# Rezoning Transportation Analysis

Petition Number: #2021-277

General Location Identifier: 15501125, 15501126

## Revision Log:

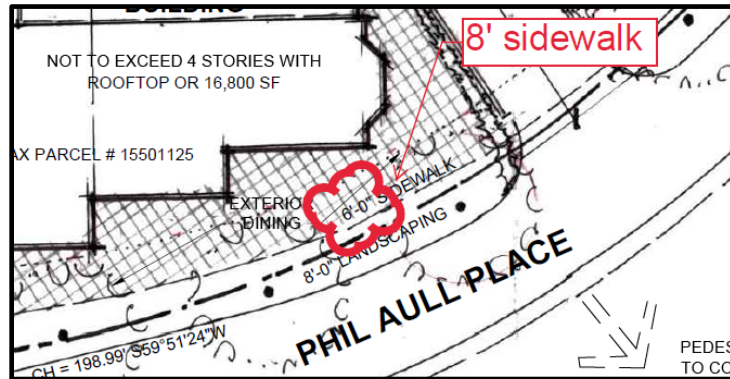
### 3. ~~Outstanding Comment from 5-18-22:~~ Revise site plan and conditional notes to commit to dedicate 40 ft (min) right-of-way from the Providence Road centerline. Provide a sidewalk utility easement (SUE) 2 ft behind the future back of sidewalk (50.5 ft from the centerline). The site plan shall label and dimension the right of way from the road centerline.

~~**Clarifying Comment from 10-26-2022:** Provide and show sidewalk utility easement (SUE) 2 ft behind the future back of sidewalk (50.5 ft from the centerline) on Providence Road.~~

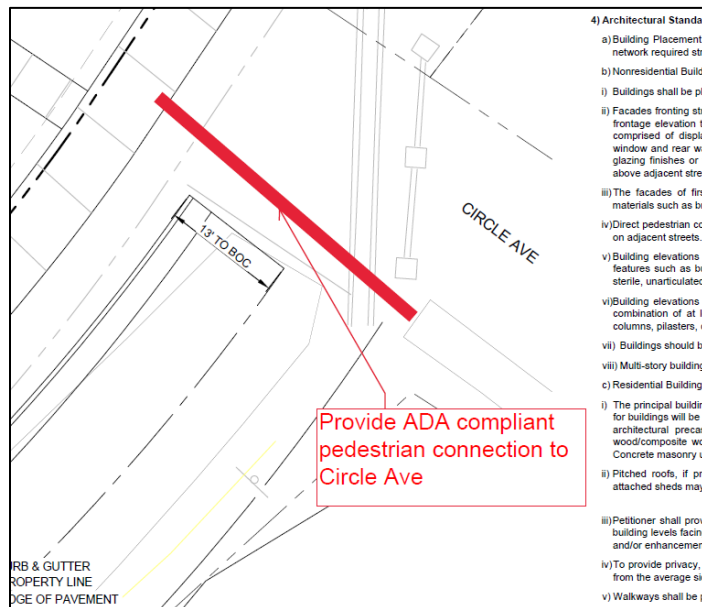
6. ~~Outstanding Comment from 5-18-22:~~ Site plan and conditional notes revisions are needed to provide an ADA compliant pedestrian connection from Phill Aull Place to Circle Avenue.

~~Clarifying Comment 10-27-22:~~ Label and add conditional note committing to ADA compliant connection.

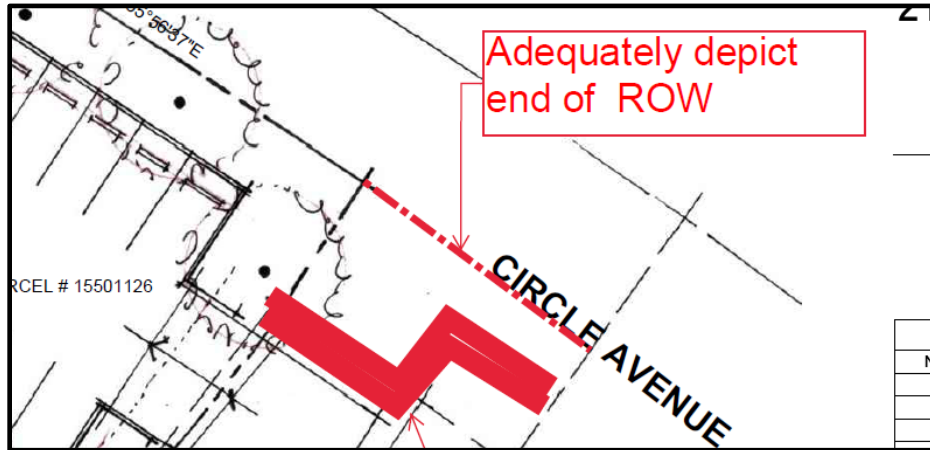
7. ~~Adequately depict the existing Circle Avenue right of way at Phil Aull Place.~~
